[Docket No. 98-NM-236-AD; Amendment 39-10767; AD 98-20-01]

Airworthiness Directives; Bombardier Model CL-600-2B19 (Regional Jet Series 100) Series Airplanes

ACTION: Final rule; request for comments.

Figure 2. Outboard Flap Go/No-Go Criteria in Take-off Position

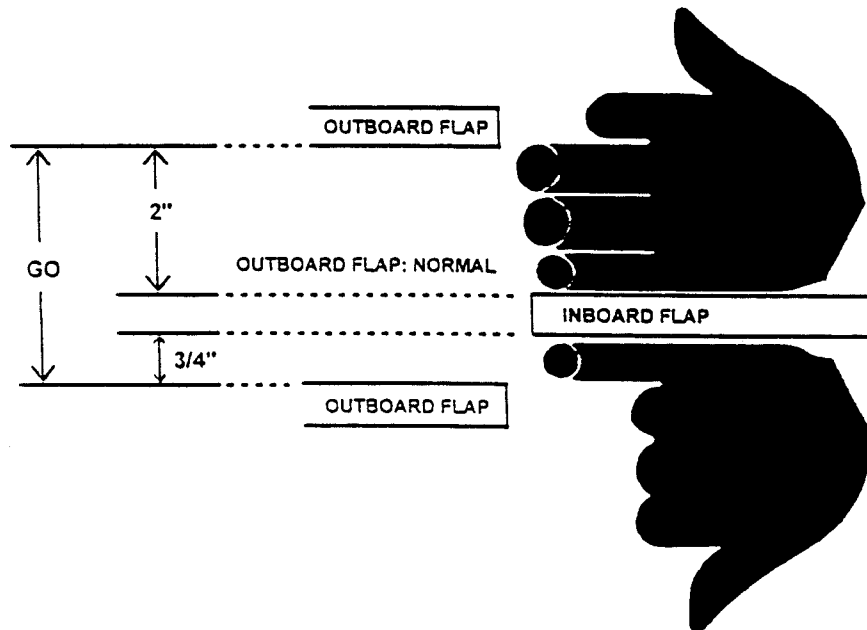
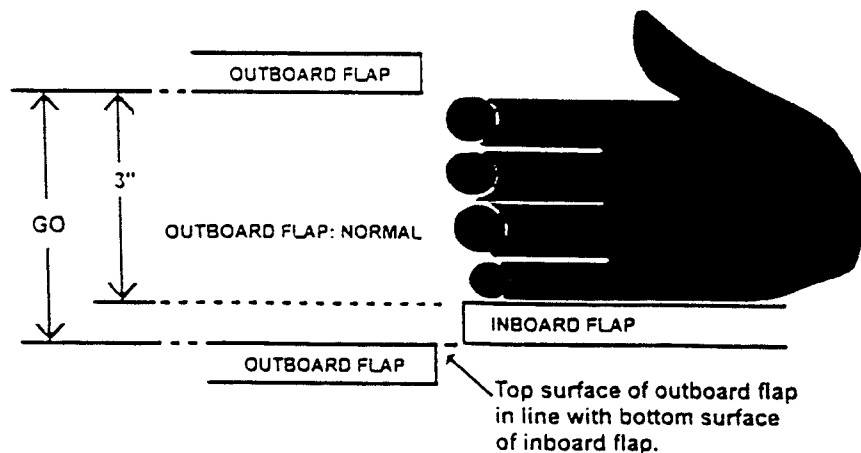
- A requirement has been added to paragraph (a)(3) of this AD to specify that any abnormal flap control event should be recorded in the Aircraft Maintenance Log Book.
- The view that is specified in NOTE 2. of the Appendix (Part 2) of the Canadian airworthiness directive for the outboard flap go/no-go criteria in take-off position has been further clarified in Figure 2 of this AD.

IMPORTANT: If the outboard flap position is outside the "GO" range, as shown in figure 2., further flight is prohibited until required maintenance actions have been accomplished.

If the outboard flap position is outside the "GO" range as shown below, further flight is prohibited.

Whenever the outboard flap position indicator is outside the "GO" range as shown in Figure 2, or whenever directed to do so by the Maintenance Procedure above, perform the following procedures:
